Braidwood Station, Units 1 and 2
Facility Operating License Nos. NPF-72 and NPF-77
NRC Docket Nos. STN 50-456 and STN 50-457

Subject: Braidwood Station Interval 2 Inservice Inspection Program:
Relief Request I2R-32, Alternative Requirements for Successive Inspections
of Unit 2 Reactor Vessel Weld

Relief Request I2R-32

Safety Evaluation by the Office of Nuclear Reactor Regulation
Commonwealth Edison Company
Reactor Vessel Shell Weld Indication Evaluation³
Braidwood Nuclear Power Station, Unit 2

RELIEF REQUEST I2R-32
REVISION 0
(Page 5 of 5)
Figure 1
"Surface Proximity Rule" of Code Case N-526

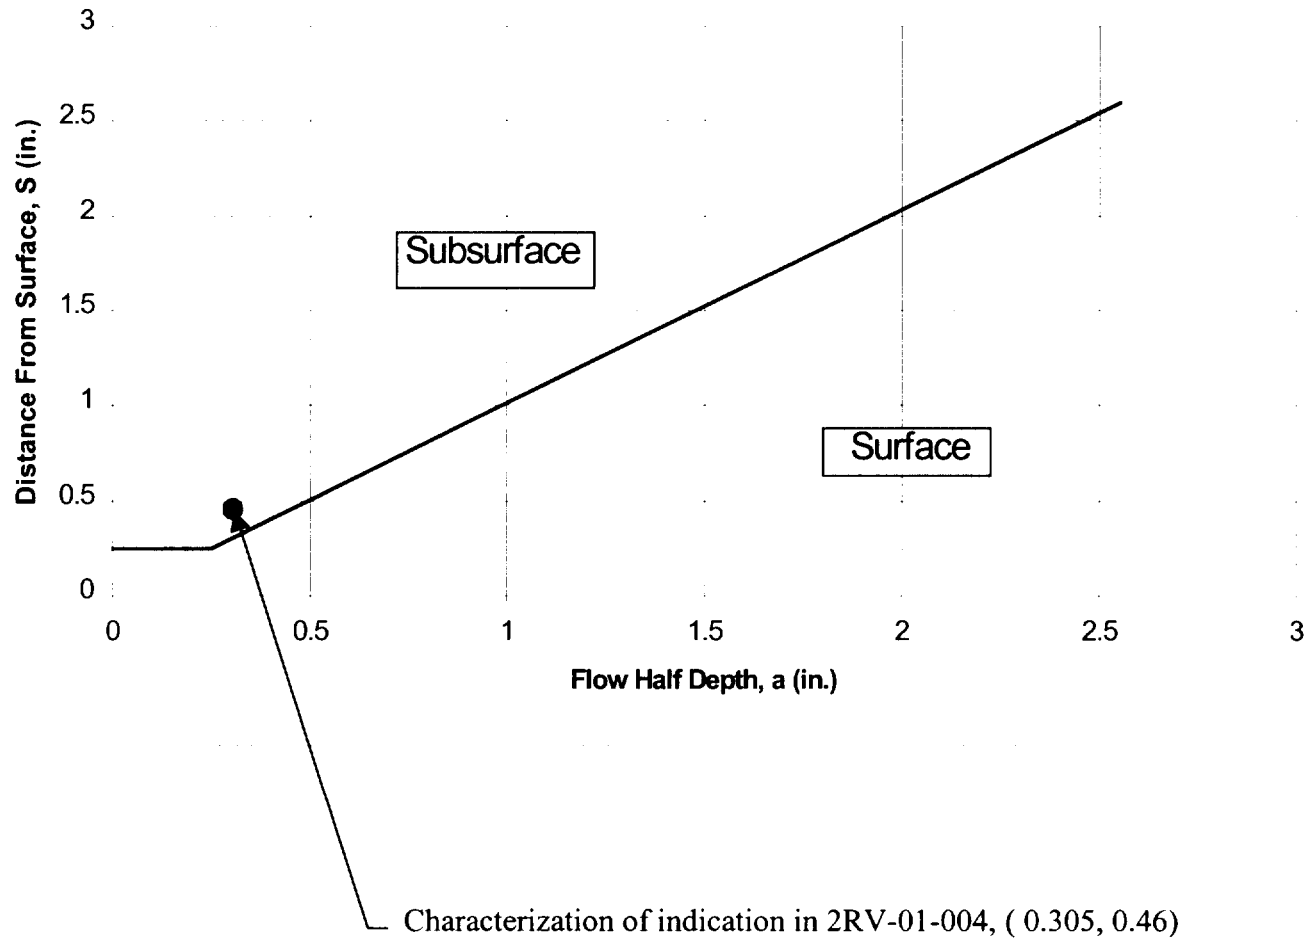
(a) the flaw is characterized as subsurface in accordance with Figure 1.

With a distance from the (outer) surface, S, of 0.46 inches and a Flaw Half Depth, a, of 0.305 inches, the indication in weld 2RV-01-004 is characterized as subsurface per the criteria of ASME Section XI, IWA-3000 as well as by the more conservative "Surface Proximity Rule" figure of Code Case N-526, (see Figure 1 on page 5).

Figure A-2.6 Evaluation Chart for Nozzle Shell to Intermediate Shell Weld

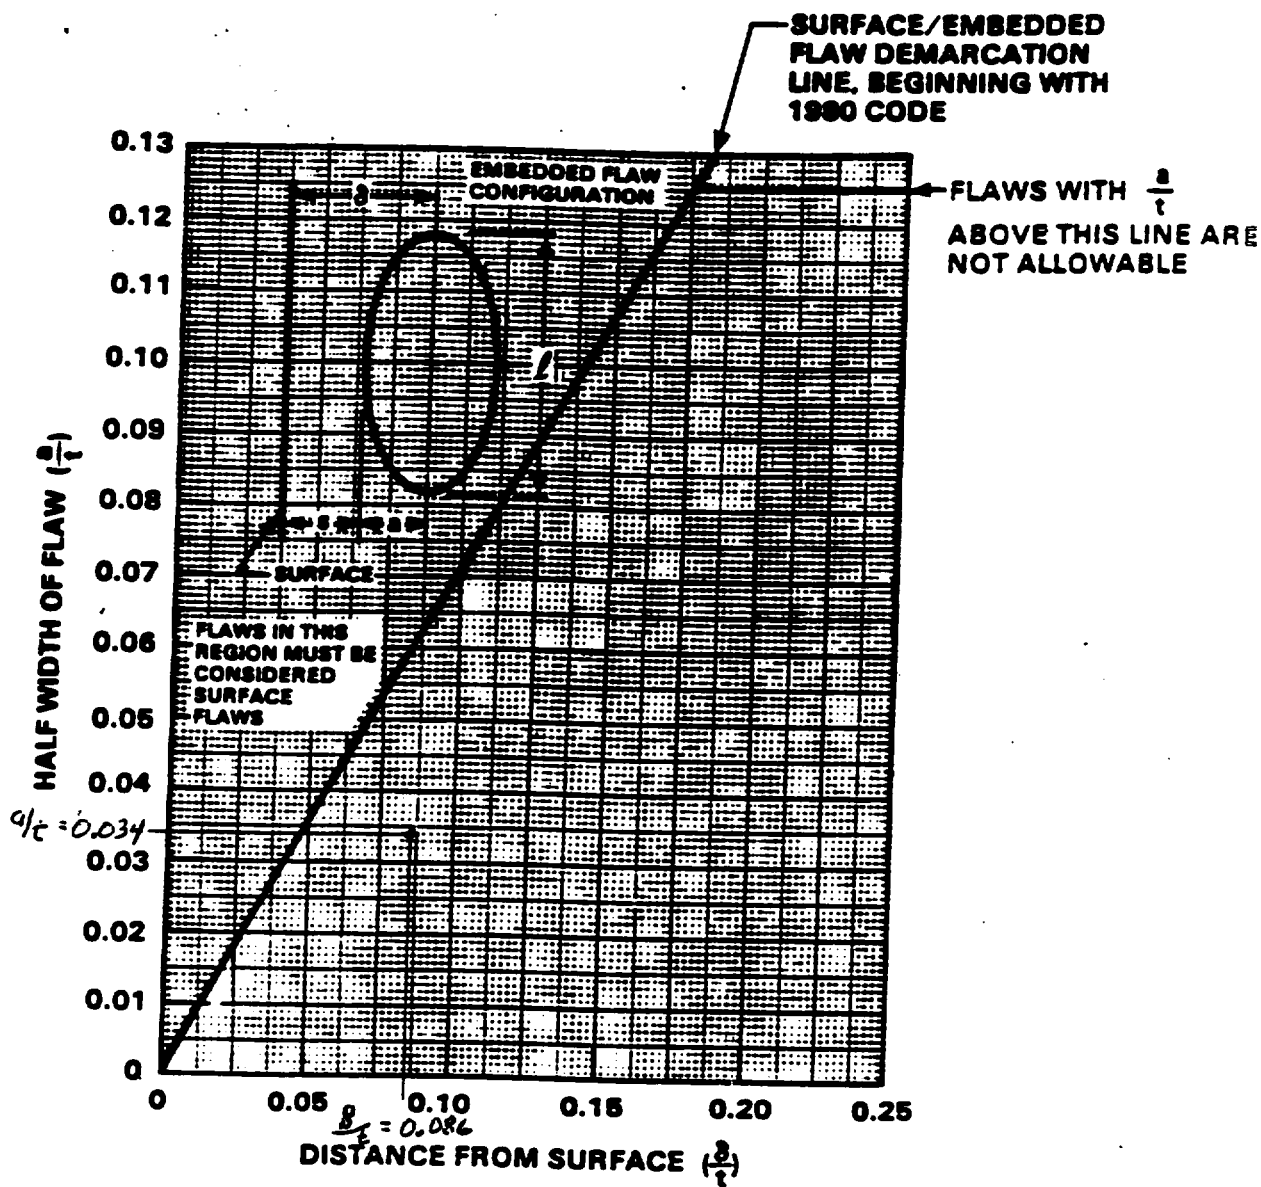
The staff has assessed the licensee's designation of this detected flaw as an embedded flaw using Figure 4 (Figure A-2.6 in WCAP-12046) and the licensee's flaw evaluation using Figure 5 (Figure A-2.5 in WCAP-12046) of the submittal. Since there is no evaluation chart for the embedded flaw at this location, the licensee conservatively used the evaluation chart for a surface flaw (Figure 5) in this application. The staff determined that the licensee applied the handbook charts adequately.

The staff also verified the validity of the handbook charts of Figures 4 and 5. The staff verified that Figure 4, which was used to determine whether an indication is a surface flaw or an

embedded flaw, was developed in accordance with IWA-3000 of Section XI of the ASME Code, and is therefore acceptable. The staff reviewed background and technical basis in WCAP-12045, but required additional information to verify Figure 5. As a result, the licensee provided additional information by letter dated November 25, 1997, detailing the process used to develop the flaw evaluation chart of Figure 5.

Based on the staff's evaluation, the staff concluded that the methodology and criteria used in generating flaw evaluation charts for the RPV of Braidwood 2 (Figures 4 and 5) are in accordance with Section XI of the ASME Code. Further, the staff confirmed that the licensee applied these charts adequately in its flaw evaluation. Hence, the reported flaw is acceptable without repair for continued operation.

Figure A-2.5 Evaluation Chart for Nozzle Shell to Intermediate Shell Weld

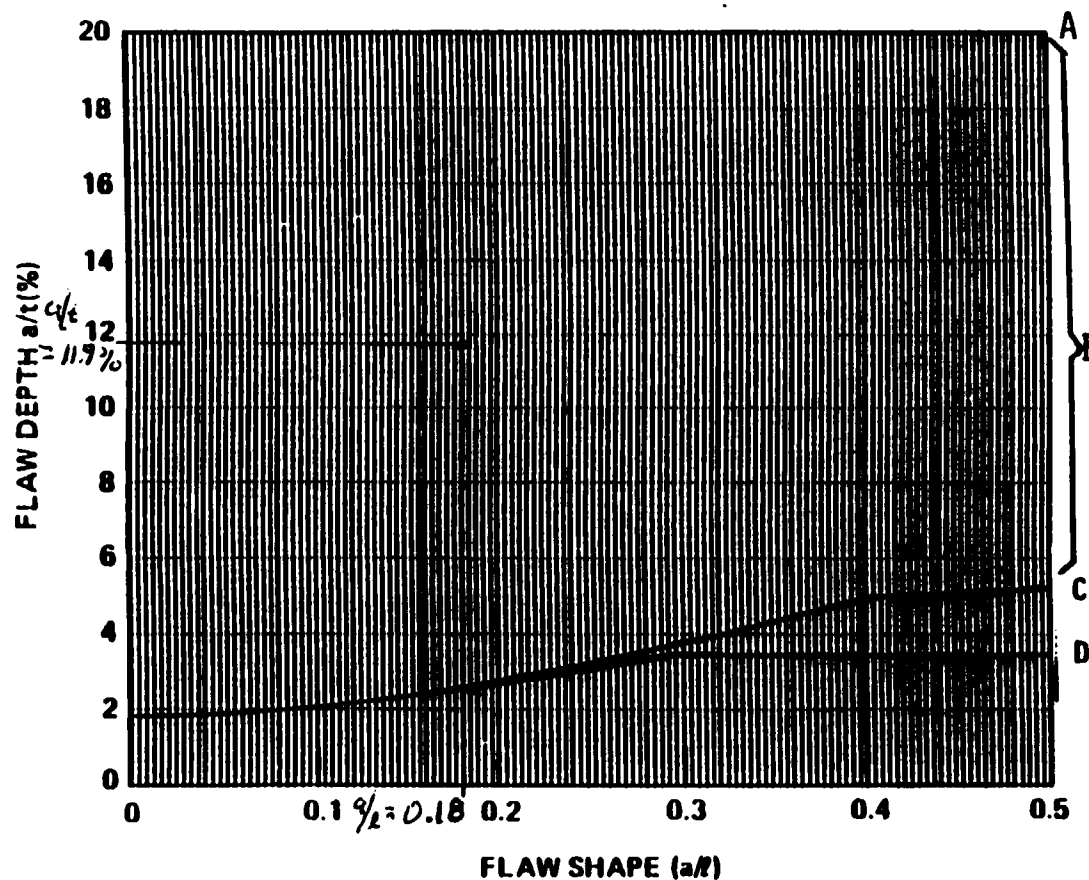
The additional information revealed that the most severe transients for outside surface flaws in the upper shell transition region are the pressure transients, i.e., the cold hydro test at 3105 psi for the normal and upset conditions and the large steamline break for the emergency and faulted conditions. The stress distribution for each of the transients was obtained using a detailed finite element model of the RPV. The applied stress intensity factor (applied K) was then calculated through the influence coefficients of Raju-Newman. The allowable fracture toughness for the nozzle shell to the intermediate shell weld at 200°F with an initial RT_{NDT} of -25°F is 200 ksi(in)^{1/2}. This toughness value remains unchanged with the time because there is no irradiation effect. Based on the ASME safety margin of (10)^{1/2} for the normal and upset conditions, the allowable depth for the assumed crack geometry of half crack depth to crack length ratio (a/l) of 0.01 is 0.269T (T = the RPV wall thickness). Based on the ASME safety margin of (2)^{1/2} for the emergency and faulted conditions, the allowable depth for the same crack geometry (a/l = 0.01) is 1.0T. Therefore, the normal and upset conditions are controlling, and the limiting allowable for the flaw evaluation chart is .269T. Similar calculations were performed for a/l equal to 0.1667 and 0.5, and the results confirmed that a/l of 0.01 is limiting.

The licensee also presented crack growth values corresponding to 10, 20, 30, and 40 years of service. They are negligibly small, and the limiting allowable crack depth remains essentially the same at .269T for the above specified different years of service, making the limiting curves for various service years appear outside the region of concern (crack depth of 20% T) in Figure 5. Consequently, the staff determined that the flaw evaluation methodology presented above is appropriate, and Figure 5 can be used to perform flaw evaluation in this application.
